Sydney Metro Martin Place Station Precinct – Amending Stage 1 Concept Proposal (south site building envelope) Sydney Metro Martin Place Station Precinct. Response to submission by the City of Sydney Council 24.09.18

We write in response to the submission made by the City of Sydney Council dated 24 September 2018 in relation to the Sydney Metro Martin Place Station Precinct – Stage 1 Amending DA.

Fig 01: Attachment A from CoS submission dated 24.09.18 showing proposed returns to the southern corners of the tower above (approx.) 45m

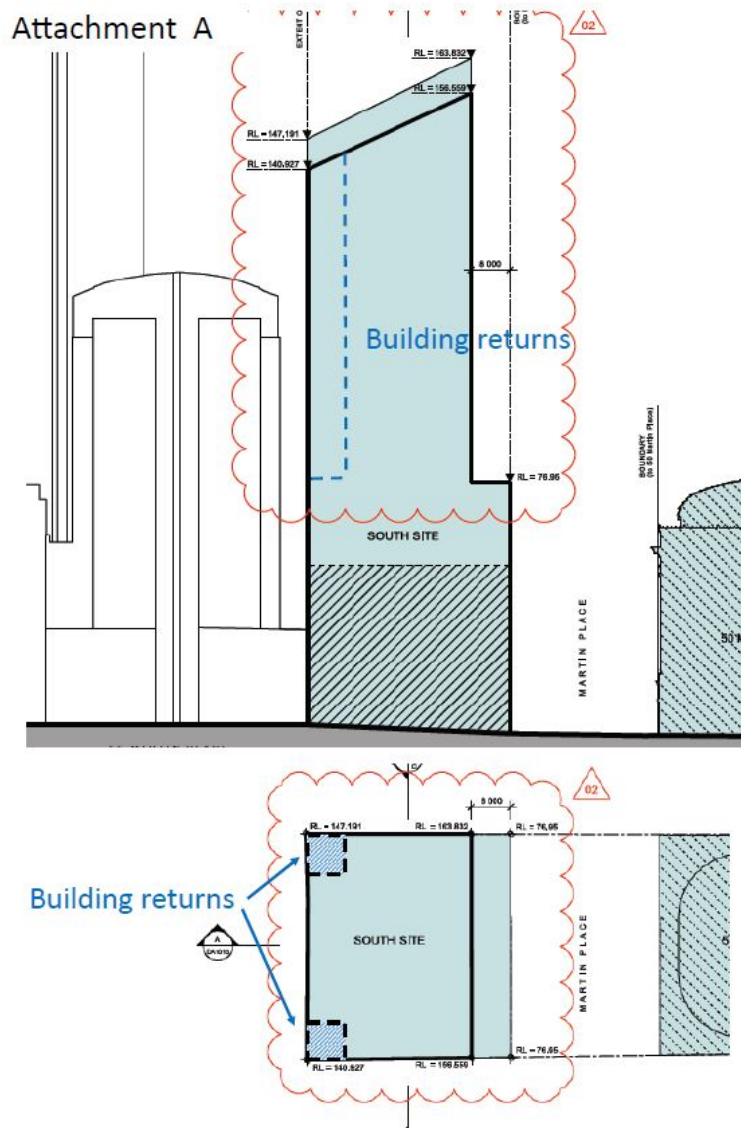
In addition to these concerns they are proposing that 'building returns be incorporated in the southern corners of the envelope as a transition to the adjoining development to the south above the podium height. CoS suggest that this would in part assist in achieving the outcome of the PACs' advice of reinforcing the importance of the urban character and integrity of Martin Place and the associated city blocks. They recommend a return of 8m x 8m for each corner of the South Tower above a nominal 45m podium height.

The idea of recesses or 'returns' in the south wall of the South Tower as proposed by the CoS has been extensively studied and consulted through the Sydney Martin Place Metro Precinct Metro and OSD DRP process. The reasons that this strategy has not been adopted are as follows.

Fig 03: Perspective of the Stage 2 DA from the south east along Elizabeth Street with an 8 x 8 m recess as proposed by the CoS. This image demonstrates the negative impact returns in the south wall has on the threshold to Martin Place.

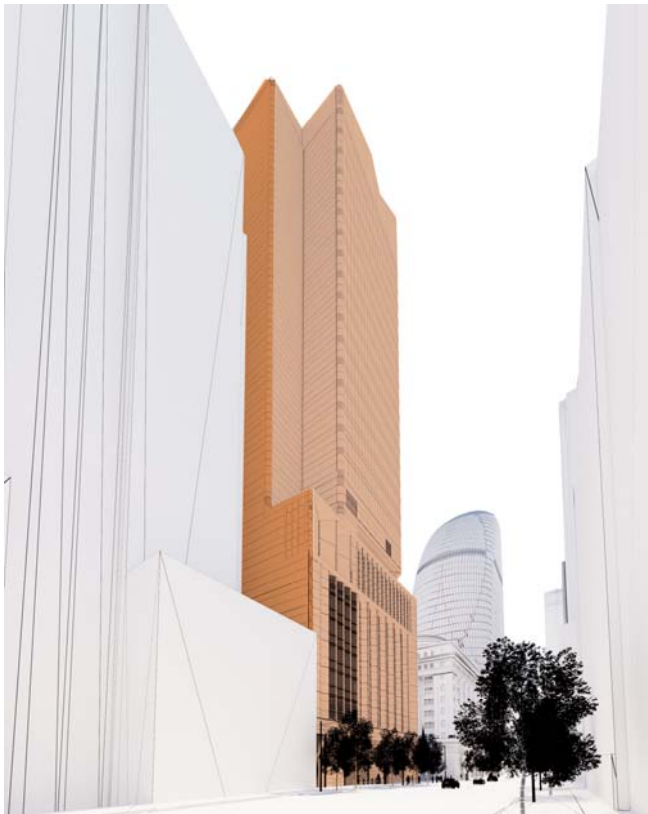
The introduction of recesses to the southern corners of the south tower as suggested by the CoS detrimentally affects the implementation of this principle by weakening the definition of this threshold edge.

Fig 06: Context plan of the current tower plan of the Stage 2 DA demonstrating how it allows various setbacks to the sites to the south of the South Site.

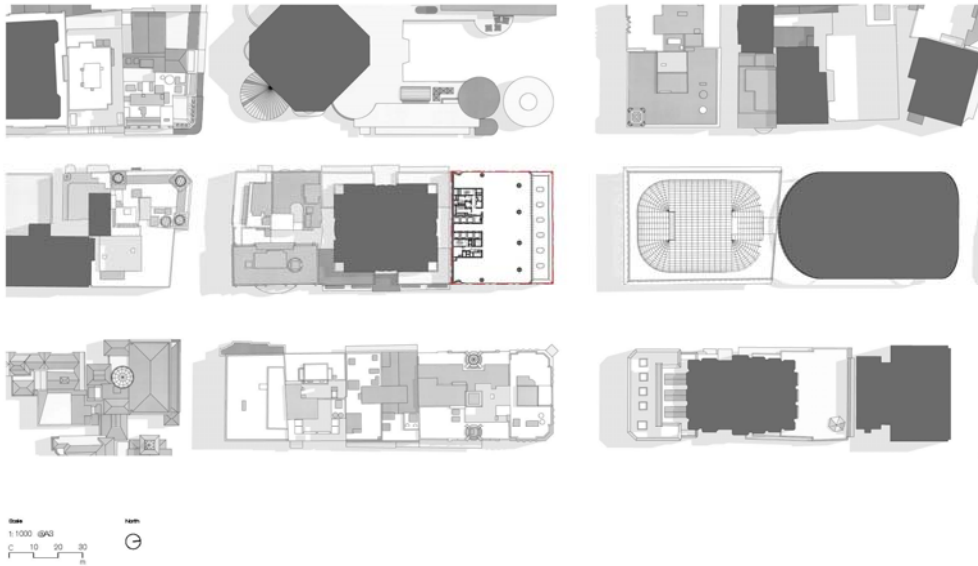
Facilitating a flexible approach to the future development of the sites to the south of the south tower.

Fig 08: Context plan of the current tower plan of the Stage 2 DA amended to show an 8x8m return as proposed by the CoS. This demonstrates how it implies that this setback be extended to the sites to the south of the South Site.

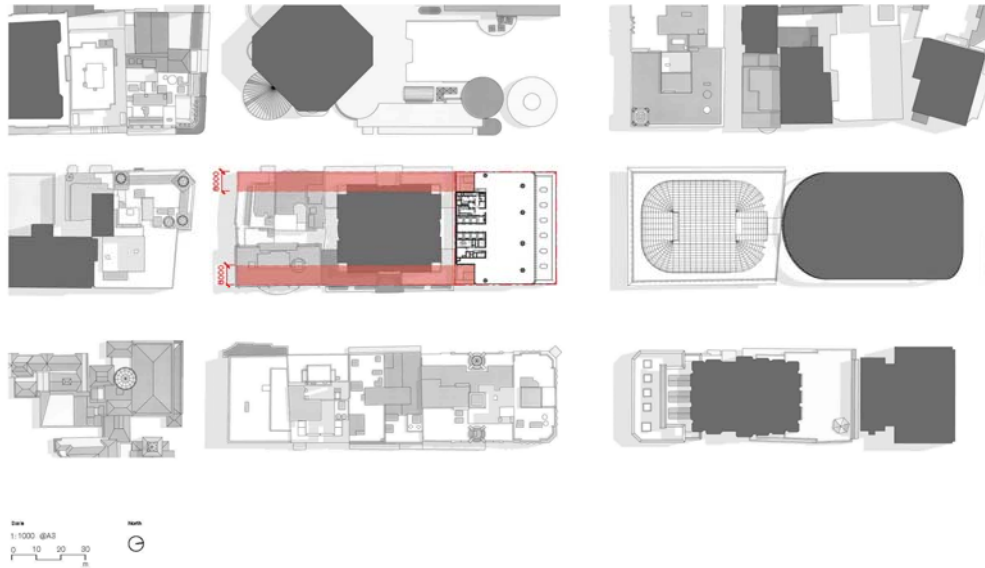
When the 8x8m corner recess is implemented, it implies that this setback is extended to the south. As the existing building to the south currently has a less than an 8m setback, the implementation of the 8x8 corner recess would create a potentially awkward built form relationship between the two buildings. It also increases the likelihood that the future redevelopment of the site to the south would constitute a 'refurbishment' of the existing built form, rather than a new built form, in order to protect the current built form footprint and retain the current setbacks.

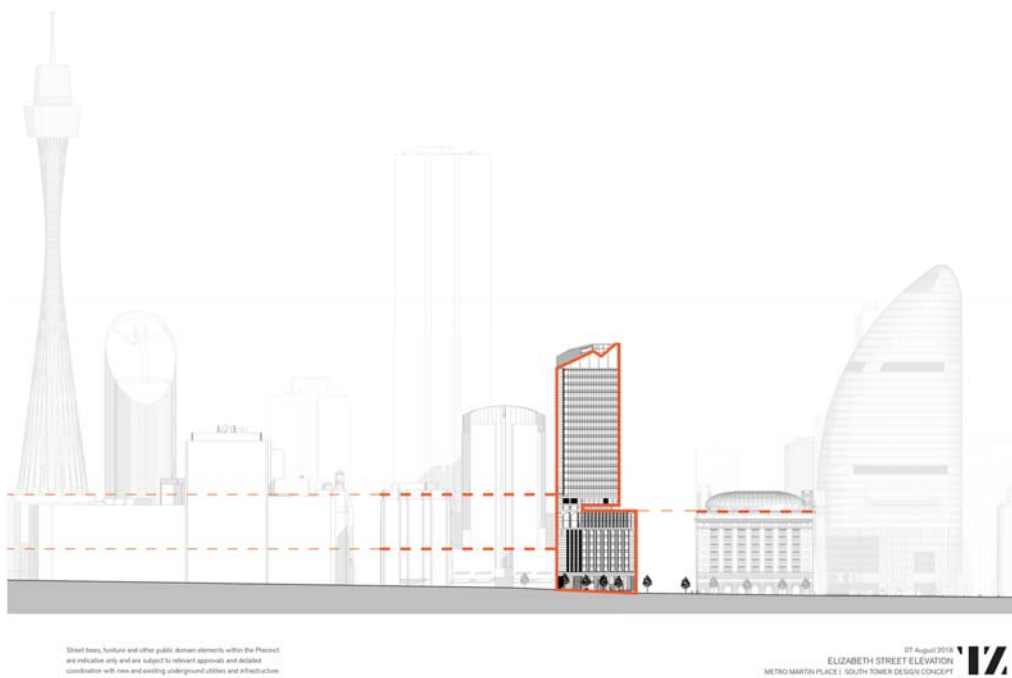
In addition to this, the current proposal for the south site building envelope does not determine the podium height of buildings to the south of the South Site. In fact, a change of podium height in future developments to the south, when compared to the defined relationship between the South Tower and 50 Martin Place, enhances the importance and distinctiveness of Martin Place in the context of the streetscapes of both Elizabeth and Castlereagh Streets, as illustrated in the figure below.

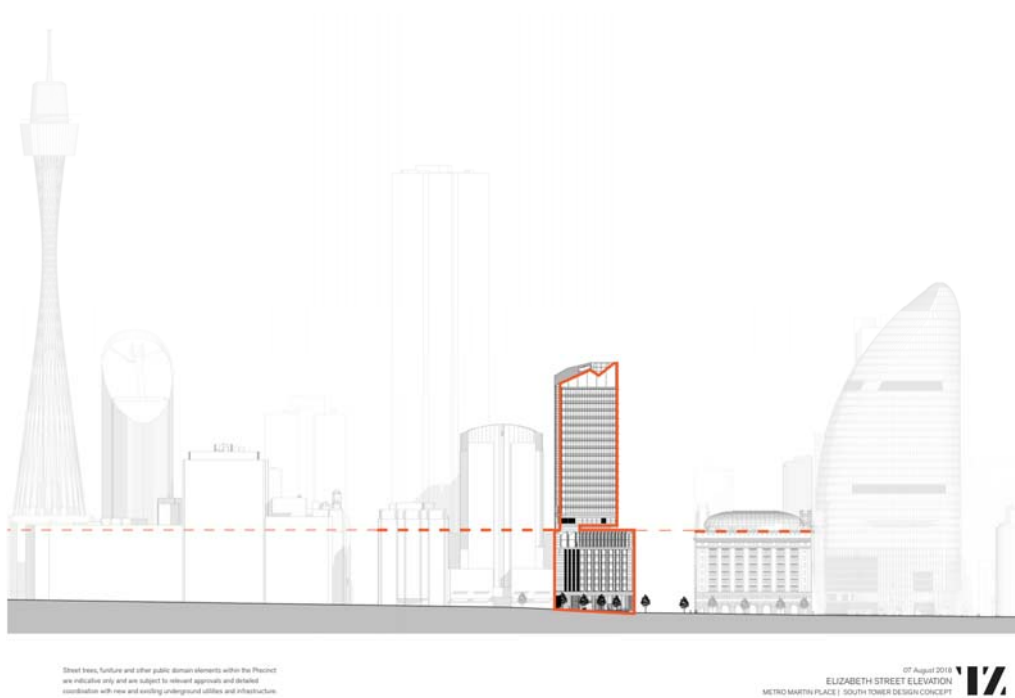
If the 8x8m recess is implemented it implies a podium height to these buildings to the south and that this podium height be the same as both 50 Martin Place and the podium on the South Site, reducing the distinctiveness of Martin Place in the context of its streetscapes.

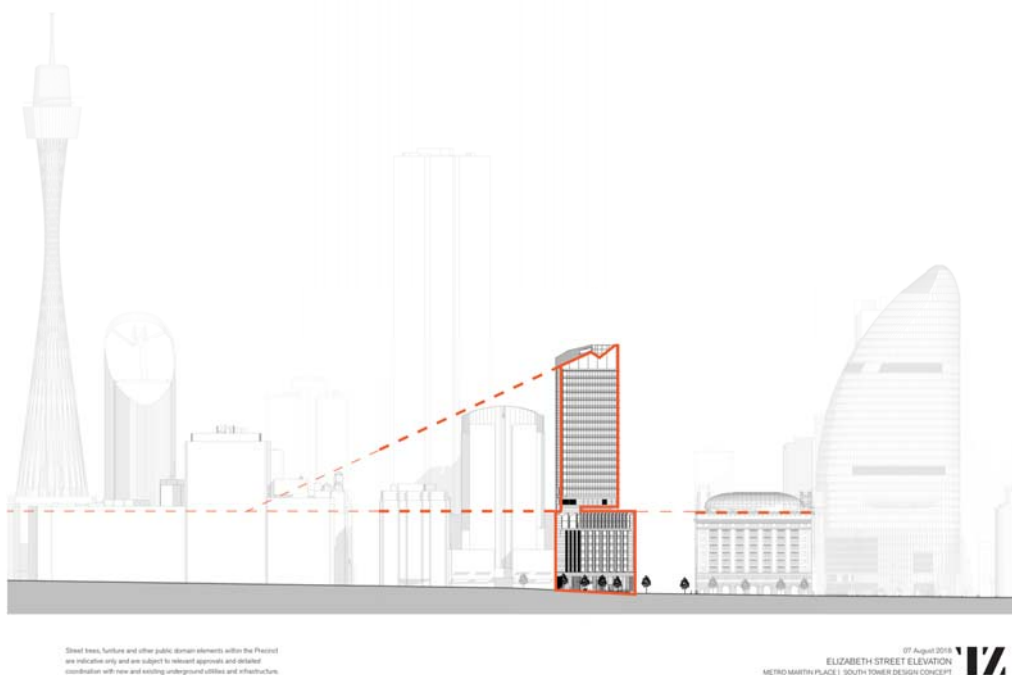
When the impact of the Sun Access Plane is considered, this defined podium height could have a potentially limiting effect on the flexibility to respond to the proportional relationship between the podium and the tower (as the height of the tower above the podium is reduced) as shown in Figure 10 below.

Fig 11: Perspective of the Stage 2 DA from the south east along Elizabeth Street demonstrating the role of the southern wall in creating an 'integrated tower form'. It is the only element that extends through all components of the building: the base, podium and tower.

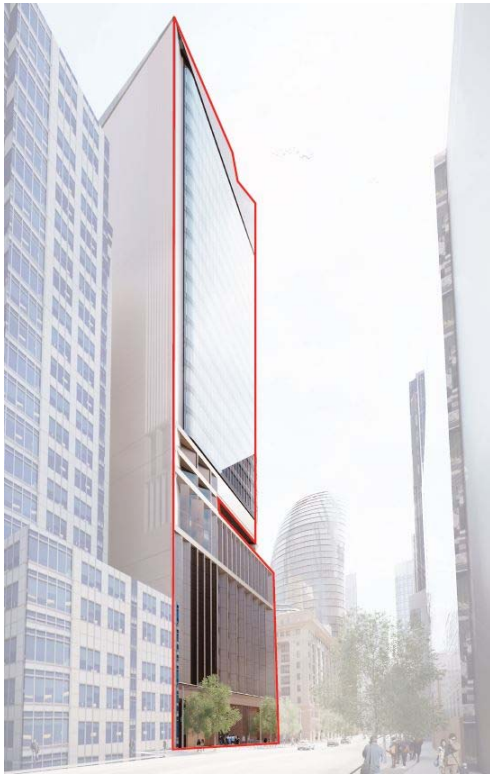
A key design principle that has been endorsed through consultation with the Martin Place Metro DRP is the principle of an 'integrated tower'. This proposed that the architectural language of the tower and podium are related in such a way that they are cohesive as an architectural design. As the design of the podium of the building has been defined by its relationship to Martin Place, this character is extended to the architectural language of the tower. This makes the architecture of Martin Place and the Metro legible in the city skyline. The continuity of the southern wall of the south tower through both the podium and the tower over is an integral part of this design approach.

The introduction of a recess to the southern corners of the south tower detrimentally effects the implementation of this principle.
